SERVICE BULLETIN

M1509 2020-02-13

M1509: MILWAUKEE-EIGHT CYLINDER FLANGE NUT USAGE

Figure 2. Flange Nut Lubrication Area

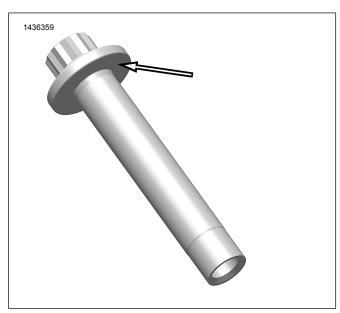
An additional change is the lubrication of the flange nut. Verify that only the bottom of the flange nut receives lubrication. Do not allow lubrication on the cylinder stud or on the internal threads of the flange nut.

- Do not install used flange nuts on MKE-8 vehicles when servicing, always replace with new OEM (Original Equipment Manufacturer) parts.
- See Figure 2. Only oil the bottom of the flange when installing, not the threads of the flange nut or cylinder studs.

The engine oil used on that particular engine should be used as the lubrication for the flange nut.
